MEMORANDUM

Date: August 19, 2015
From: Marie Ennis, Gabriel Pardo
To: John Shedd
Company: Chautauqua Institution
c:
Project: Chautauqua Institution Amphitheater Study: Narrative and Questions
Project #: J3262.02

The following is a brief narrative to accompany the two options for structural work shown in the Old Structures Engineering (OSE) drawings originally dated July 15, 2015. The drawings have been revised to better coordinate with the sequence description narrative, and to address a comment from Wendel Architecture and Engineering regarding helical piles.

B.5 STEP 5 - Longitudinal Section. Grid Lines 2 & 8
Scale: 1/16" = 1'-0"

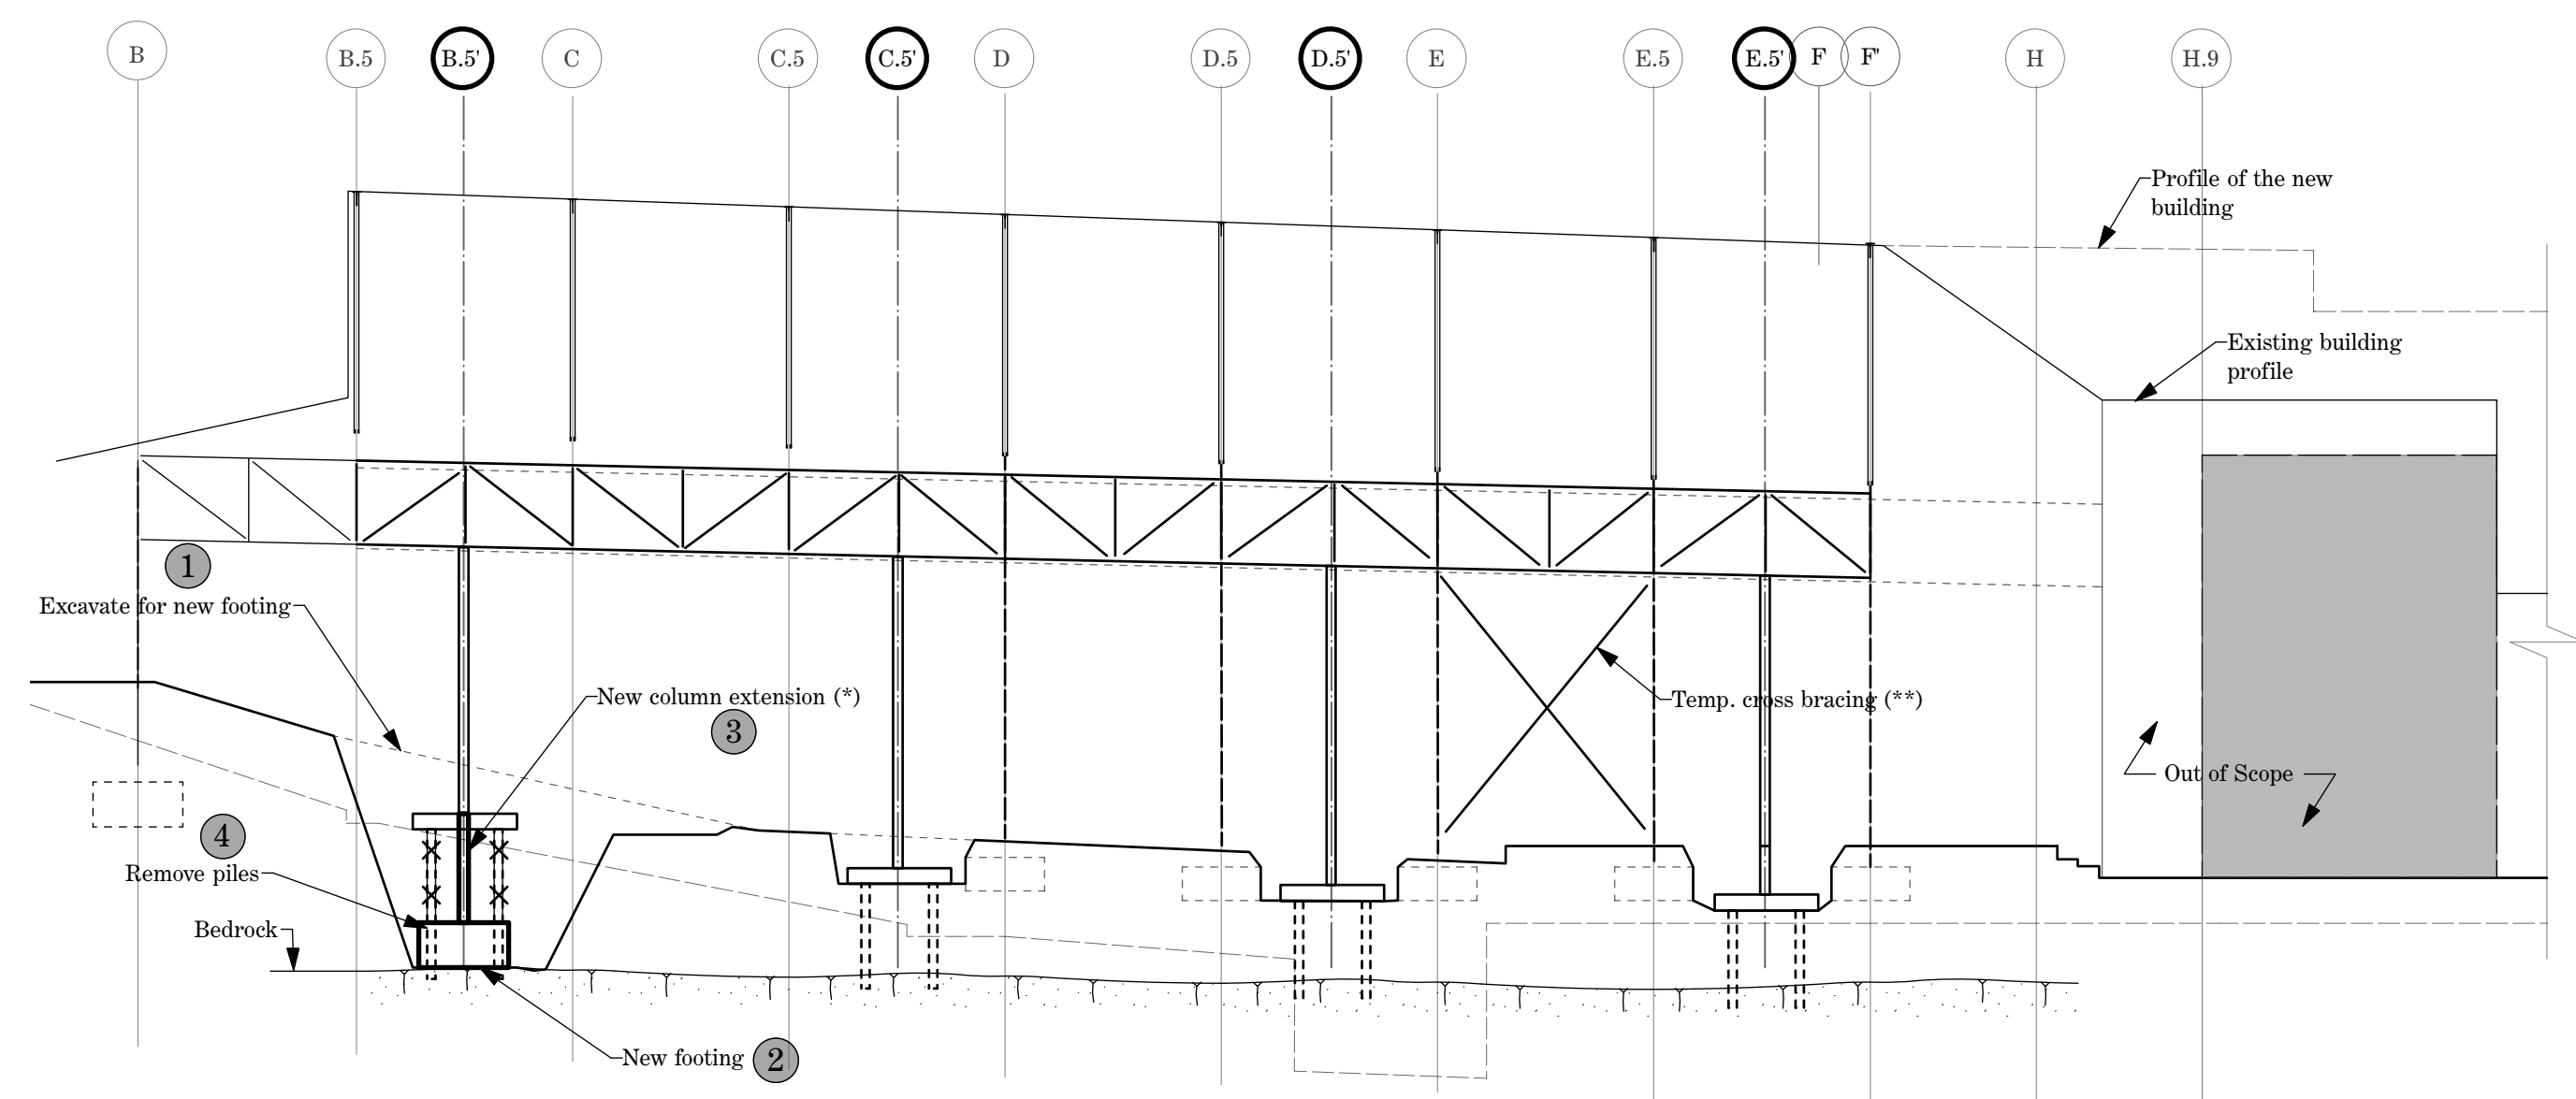
Step 5 likely creates a stability issue if helical piles are used (i.e. to unbraced length of helical pile vs. overturning moment capacity). Again, we recommend that micro piles, socketed into sound bedrock be used in lieu of helical piles.

Resolved by using micro-piles or mini-caissons.
